FSP-25-08 – Point Phase 5 – V1 Submittal review cycle

START DATE: MARCH 2025	DUE DATE: _04-07-25_	TRC/STAFF Comments issued on: __04/05/2025__
-------------------------------	-----------------------------	---

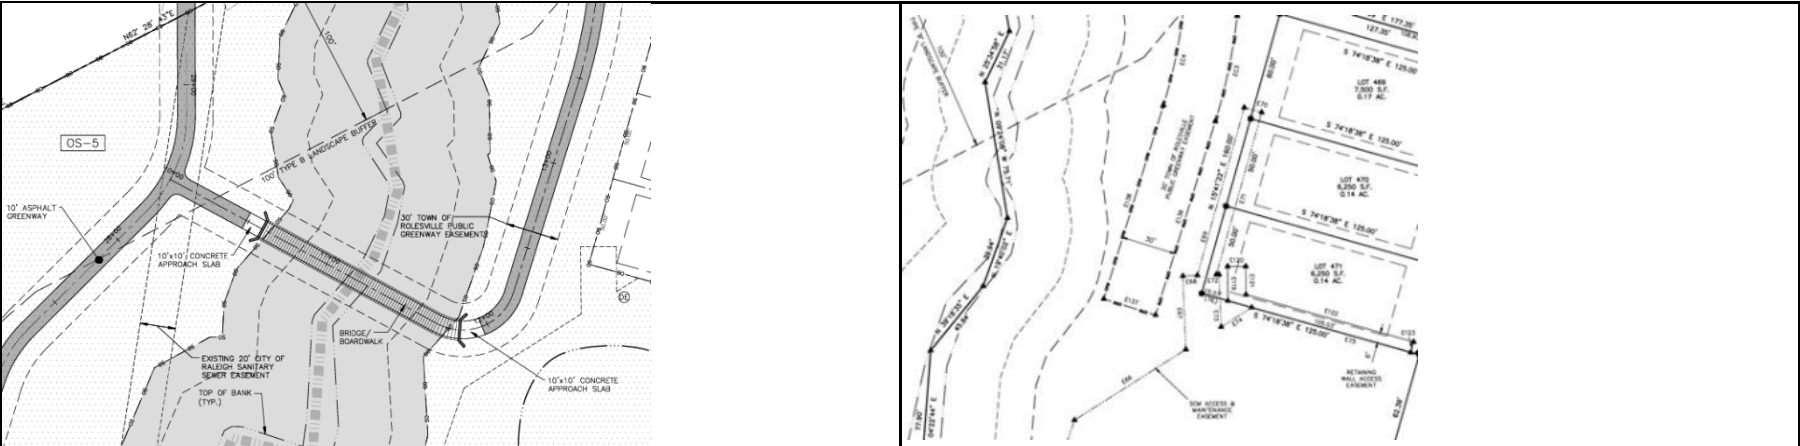
Parks & Recreation - Eddie Henderson	Please revise to show all of Greenway easement in Phase 5, include the section of bridge/boardwalk that goes over the creek. Excerpt on Left from PR 20-01 / on Right from FSP-25-08
